RE: **Grants Reclamation Project – DP-200 Renewal – Response to September 12, 2000 NMED Letter Transmitting Comments / Questions on Renewal Application**

**HOMESTAKE MINING COMPANY
Grants Reclamation Project
DP-200 Renewal**

**RESPONSES TO
NEW MEXICO ENVIRONMENT DEPARTMENT
REGARDING QUESTIONS / COMMENTS ON DP-200
RENEWAL APPLICATION
PER
NMED LETTER DATED SEPTEMBER 12, 2000**

FIGURE 6. CHLORIDE CONCENTRATIONS FOR BACKGROUND WELLS Q, R, DD AND ND.

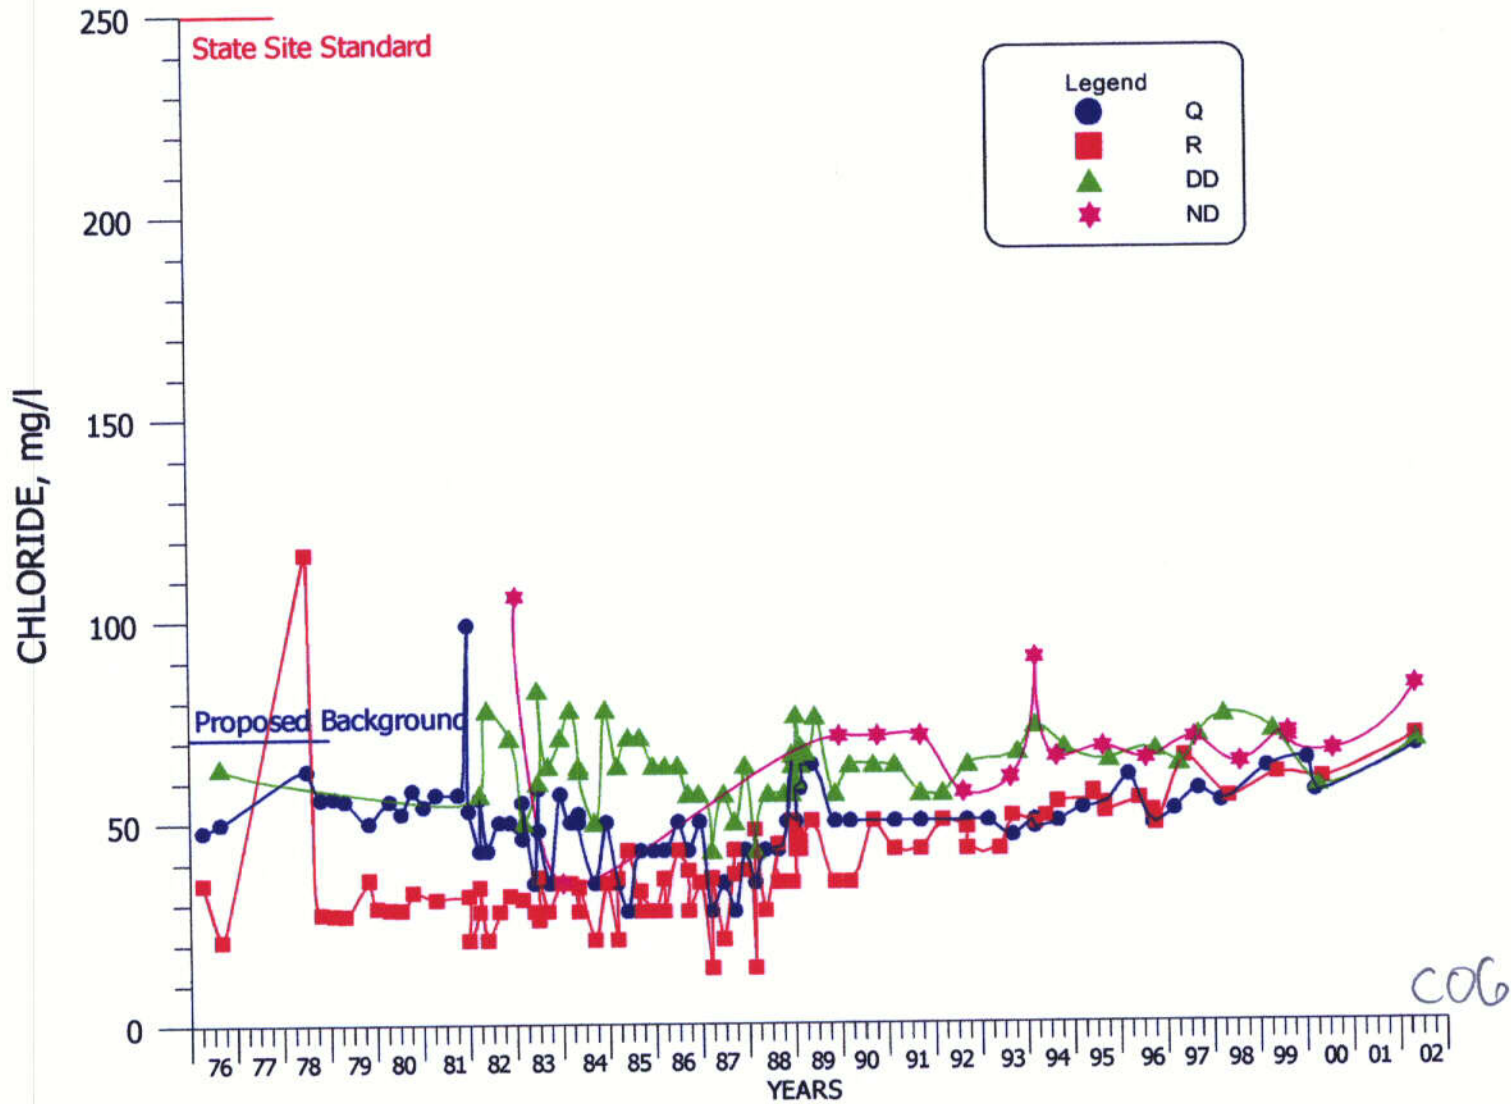
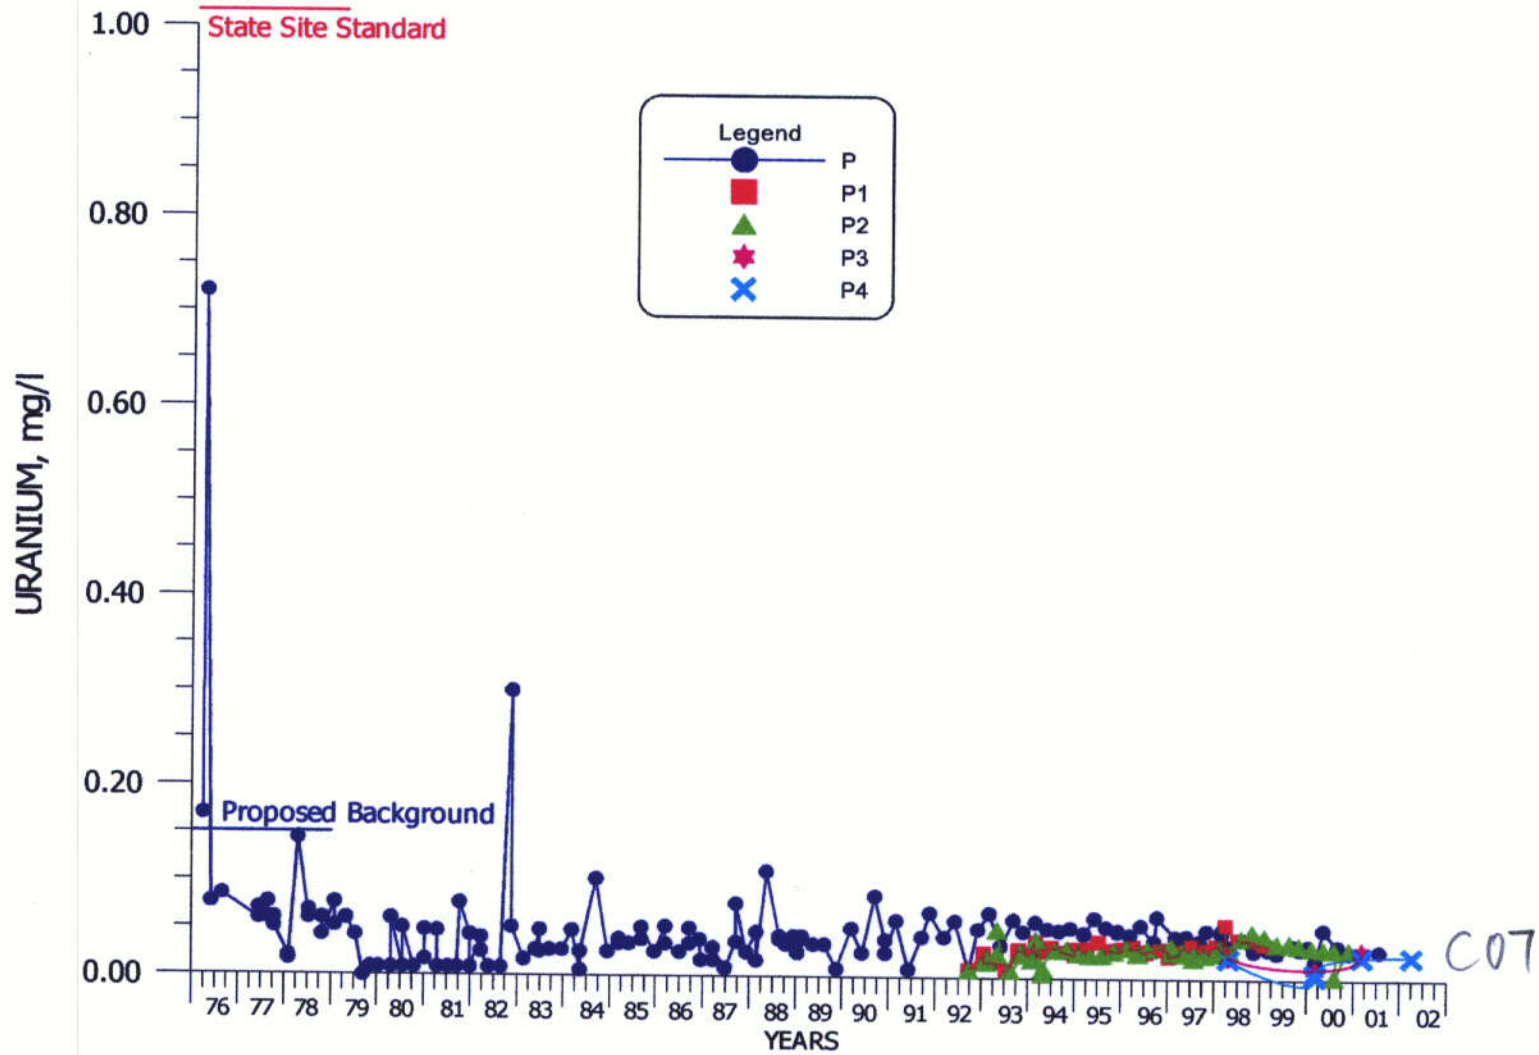
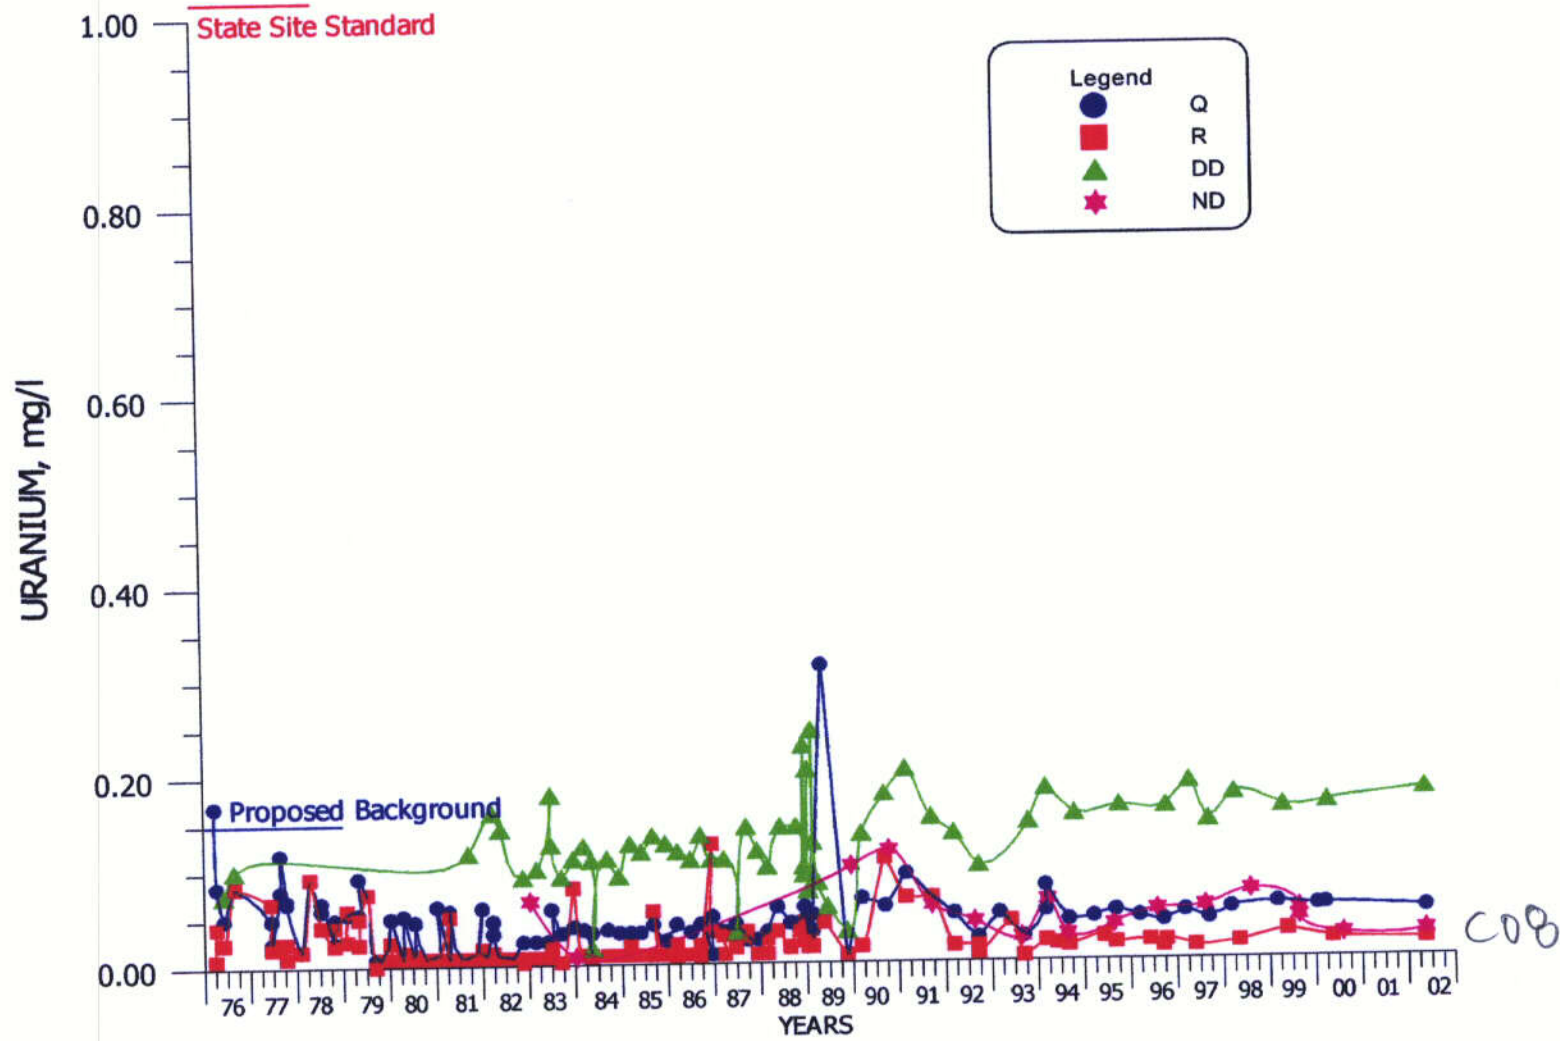
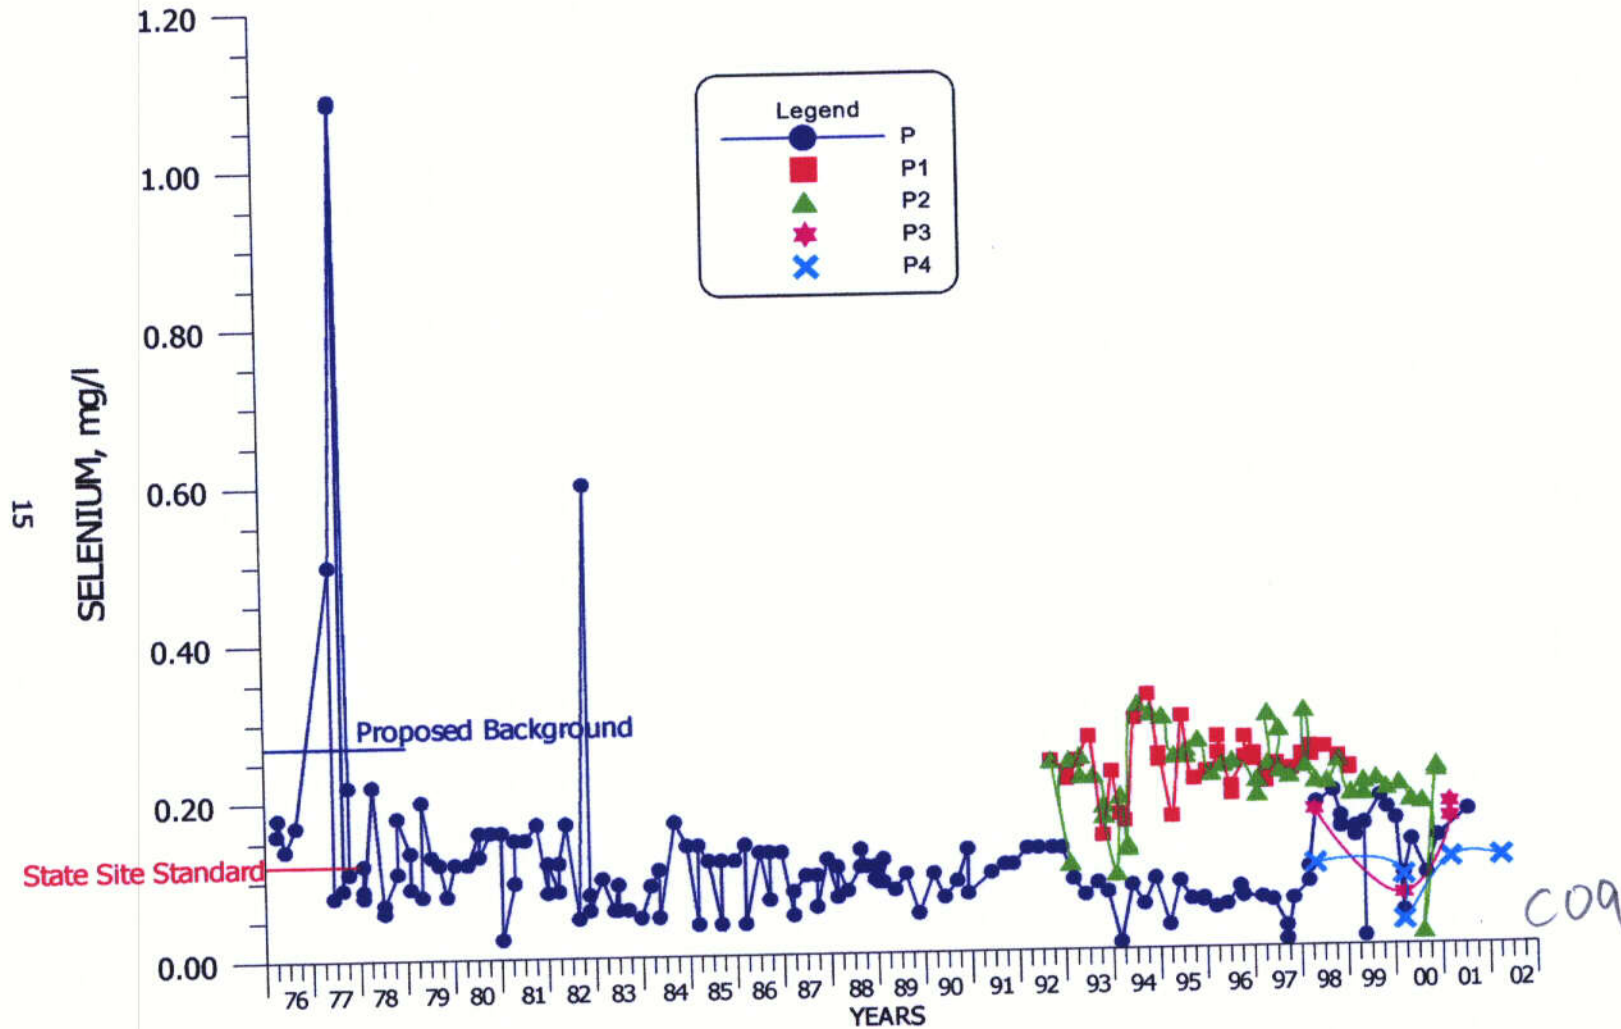
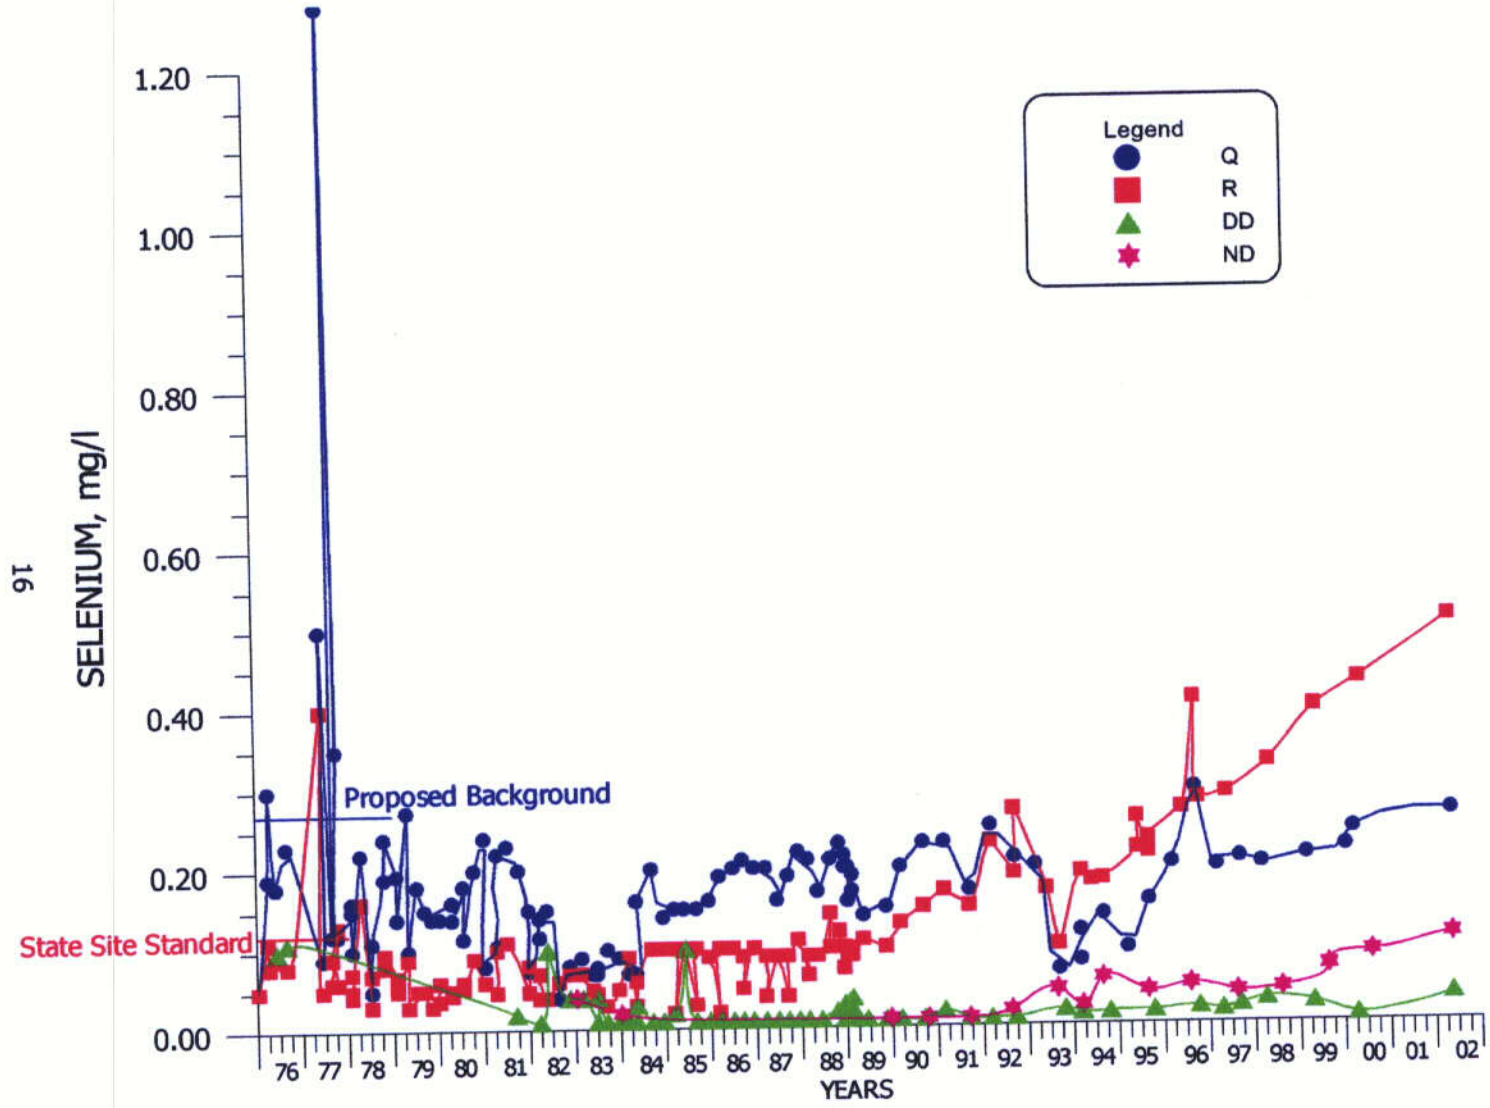
Comment: II.4. Water Quality Trends in Near Upgradient Wells

Comment: II.5.A. Graphs for Near Upgradient Data

Response: Plots of historical water quality for TDS, chloride, uranium, selenium, molybdenum and nitrate were developed for wells P, Q, R, DD, ND, P1, P2, P3 and P4 at the same vertical and time scales. The 5 'P' wells are grouped together because they are in the same vicinity of the alluvial aquifer. The remaining four background wells, which are west, north and east of the 'P' wells, are shown on the second plots. The historical plots of water-quality concentrations for the 9 background wells are presented in the enclosed figures according to the following list:

Constituent	FIGURE NUMBER	
	P Wells	Non-P wells
SO4	1	2
TDS	3	4
Cl	5	6
U	7	8
Se	9	10
Mo	11	12
NO3	13	14

The present State site standard was determined from the mean concentrations for upgradient wells P, Q and R for data from 1976 through early 1983. These mean concentrations are presented in Table 2 of the NMED's Pre-hearing Ground-water Discharge Plan Analysis for the Homestake Uranium Mill near Milan, New Mexico, published in January 1984. The use of the mean concentrations does not define the upper portion of the natural background concentrations. Also, the much shorter record does not account for the historical changes that have been observed over the last 24 years. The additional near background wells also better define the natural areal variation in the alluvial aquifer. Therefore, the present statistical analysis of full background is a much more appropriate way to define the site standards at the Grants site.
